Dresden Nuclear Power Station, Units 2 and 3  
Renewed Facility Operating License Nos. DPR-19 and DPR-25  
NRC Docket Nos. 50-237 and 50-249

Subject: Additional Information Supporting Relief Request I4R-17, Inservice Inspection Program Relief Request Regarding Examination Coverage for the Fourth Inservice Inspection Interval

**SECOND REQUEST FOR ADDITIONAL INFORMATION**  
**ON THE FOURTH TEN YEAR 10-YEAR INSERVICE INSPECTION INTERVAL REQUEST**  
**FOR RELIEF I4R-17**  
**FOR**  
**EXELON GENERATION COMPANY, LLC. DRESDEN NUCLEAR POWER STATION,**  
**UNITS 2 AND 3 - DOCKET NUMBERS: 50-237 AND 50-249**

**Figure 2:** Updated DNPS, Unit 2 Head-to-Flange Weld Inservice Examination Coverage Diagram

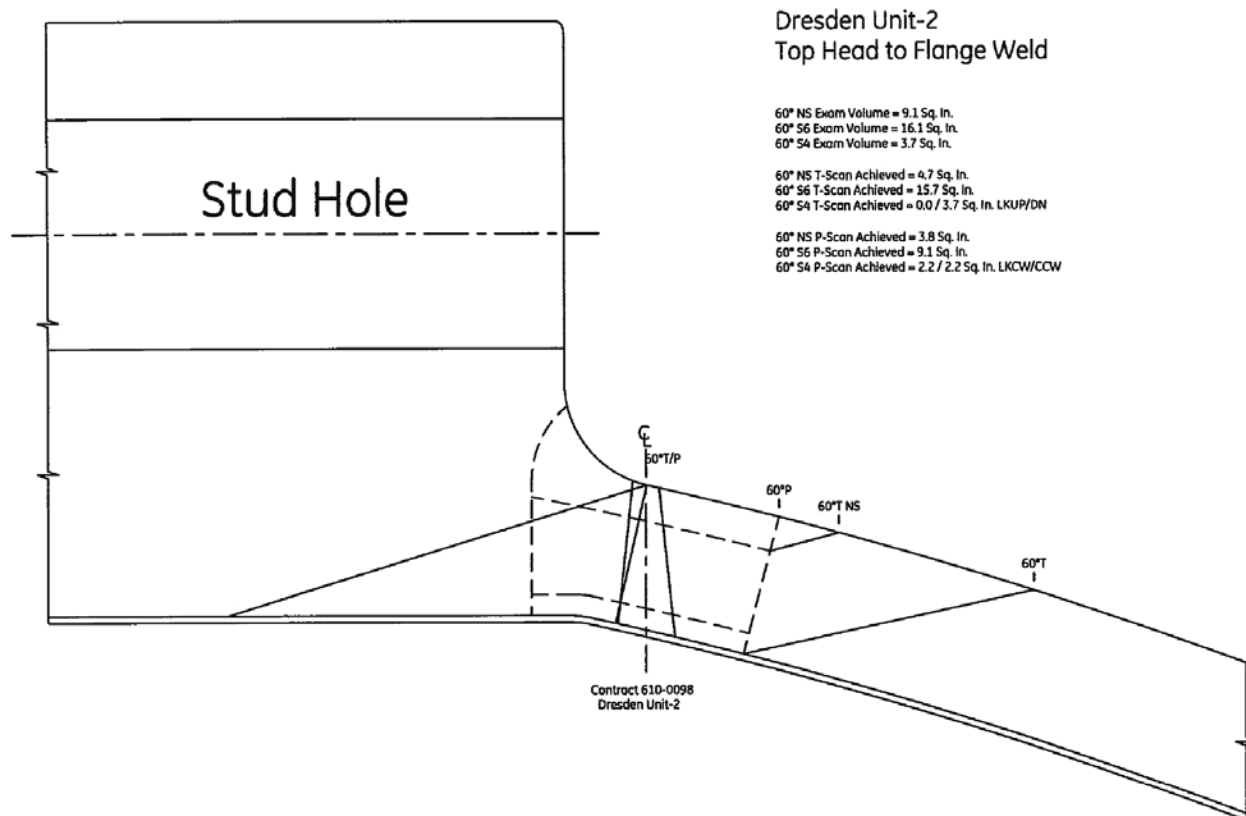
- 1) *The licensee states that, for Unit 2, only 41.7 percent coverage was obtained on the top head-to-flange weld. The drawing submitted in the RAI response appears to support the claim that examinations may only be conducted from the head side of the weld due to geometry. However, it is stated that Unit 3 was able to get 72 percent volumetric coverage, while the drawing shows the top head-to-flange welds at DNPS 2 and 3 to be geometrically similar. Please clarify why the licensee was able to obtain a marked increase in volumetric coverage on DNPS 3.*

- 2) ***In Attachment 2 of the licensee's RAI response, it appears that the top head-to-flange weld drawing on page 333 has different coverage values than the coverage calculation sheet on page 334. Please verify the information provided for the Unit 2 top head-to-flange weld in the RAI response and provide a corrected coverage sketch or coverage calculation sheet, whichever one is currently incorrect.***

Based on discussions with the vendor that performed the examinations referenced above, General Electric Hitachi (GEH), the Dresden Nuclear Power Station (DNPS), Unit 2 top head-to-flange weld coverage plot and the closure head configuration was found to be non-representative of the closure head design drawings. Additionally, the achieved coverage cross sectional area was apparently entered into the coverage calculation spreadsheet incorrectly. The actual examination coverage area value for the DNPS, Unit 2 top head-to-flange weld during the fourth DNPS Inservice Inspection (ISI) interval was 65 percent (%).

As stated above the coverage values for the DNPS, Unit 2 and 3 top head-to-flange welds are revised above. New coverage sheets and diagrams for both DNPS Units are included as Figures 1 through 4 below.

Drawing of Weld Identification No. 2/1/1001A-16/16-11

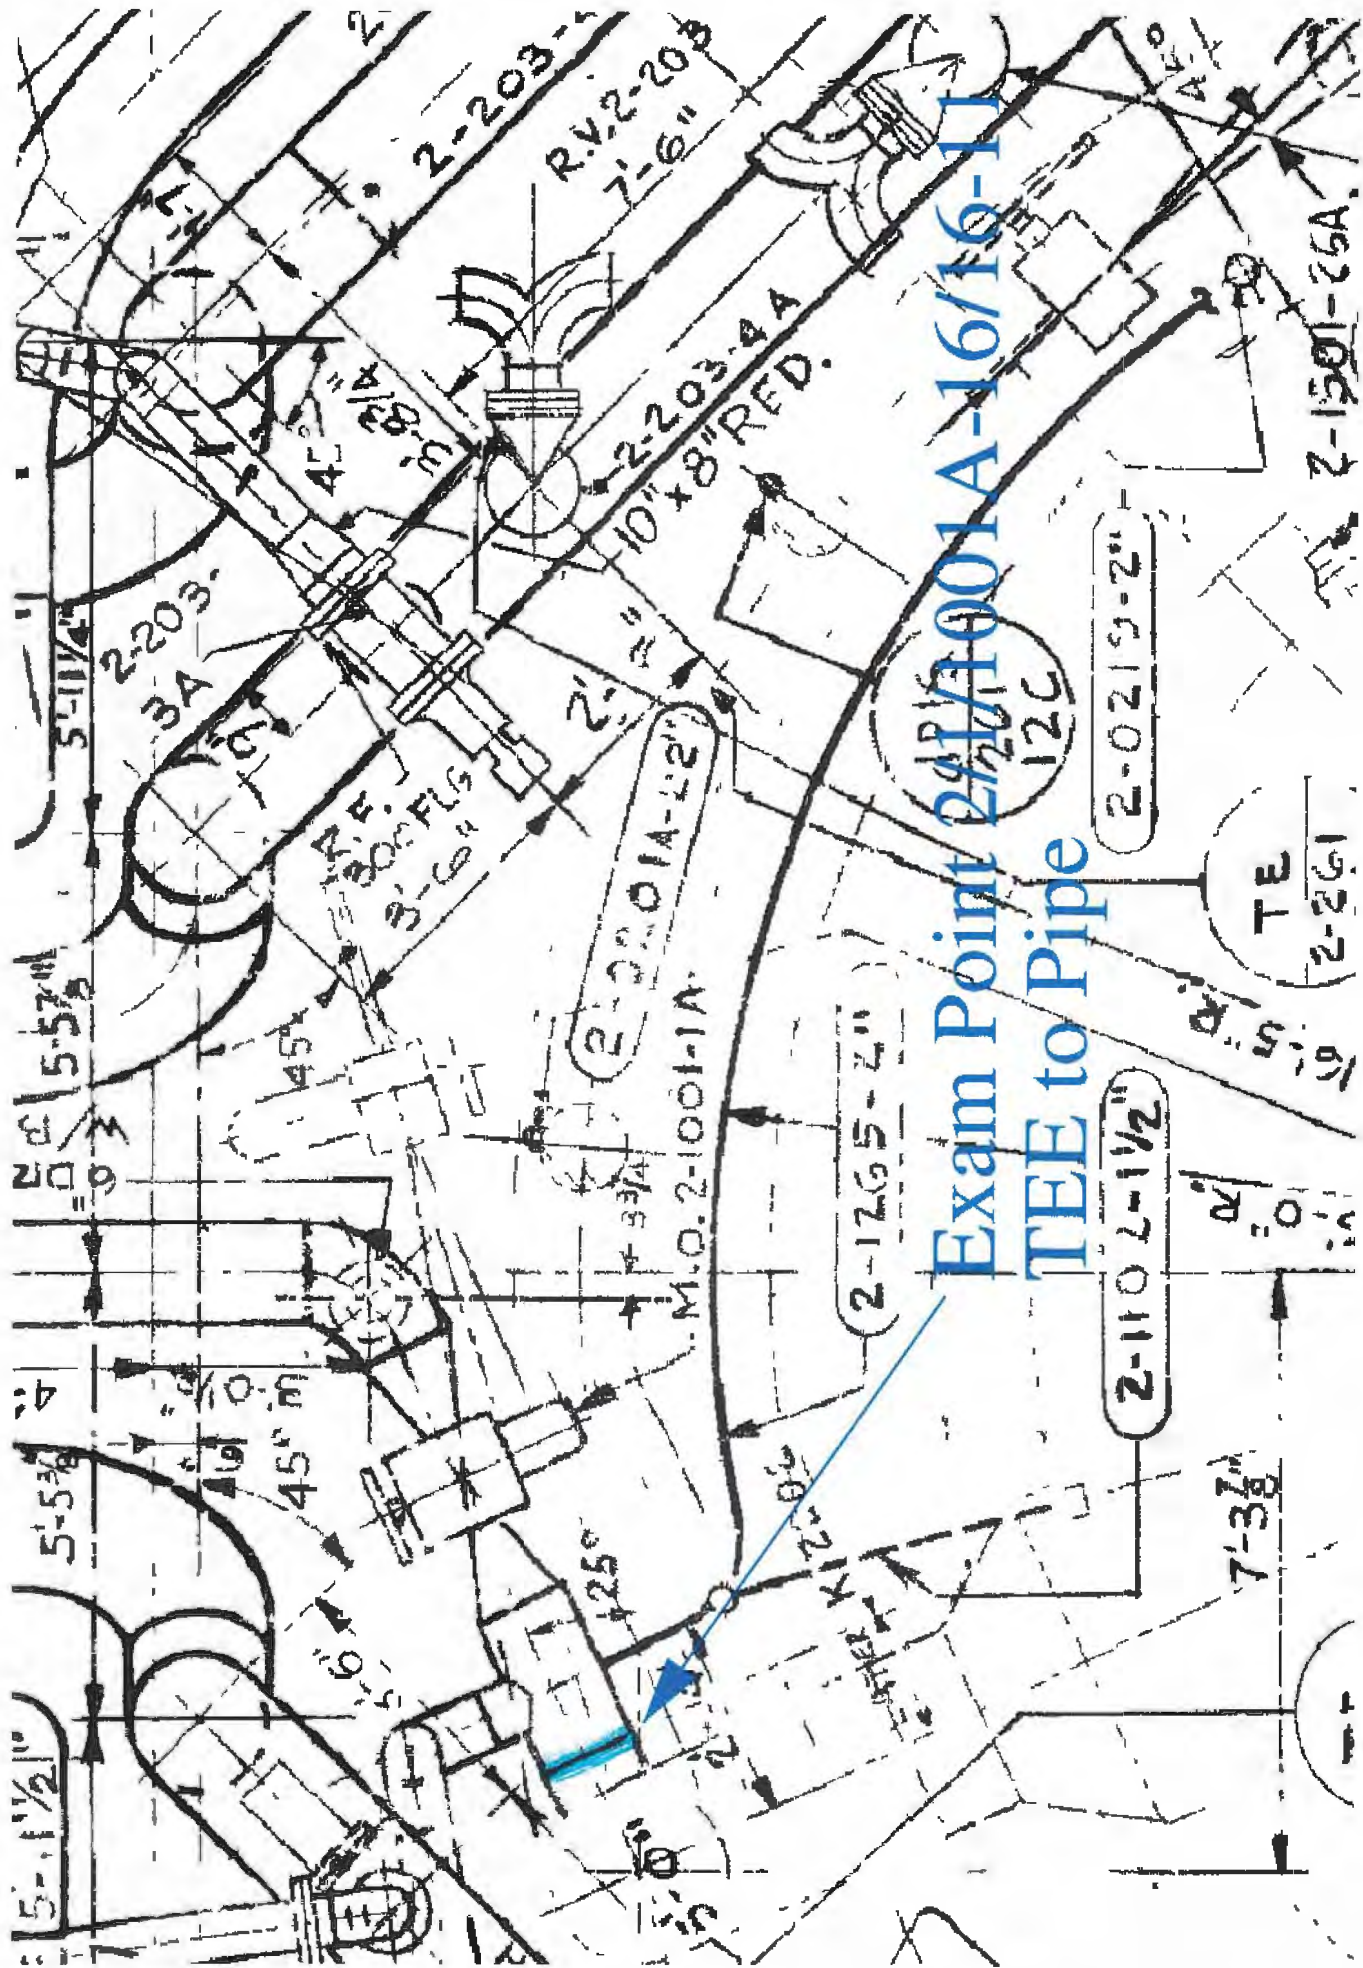
*Provide coverage plots for all RI-ISI welds listed in Tables 2.3.1 and 2.3.2 above. From the coverage sketches provided in the licensee's RAI response, it is difficult for the staff to determine how the licensee determined the coverage percentages on the welds in Table 2.3.1 and 2.3.2 as the supplied diagrams are very similar to each other yet yield very different coverage percentages.*

**Weld ID 2/1/1001A-16/16-11** is a single sided stainless steel joint. Therefore, no coverage can be obtained for one of the axial scans. Credit cannot be claimed for the far side (i.e., tee side) and the coverage for the clockwise and counterclockwise scans is limited by the configuration of the tee. This results in the examination coverage for this weld being limited to 36%. Attachment 2 provides a visual representation of the physical configuration of this welded joint and provides some insight into the difficulty in obtaining examination coverage for this weld.
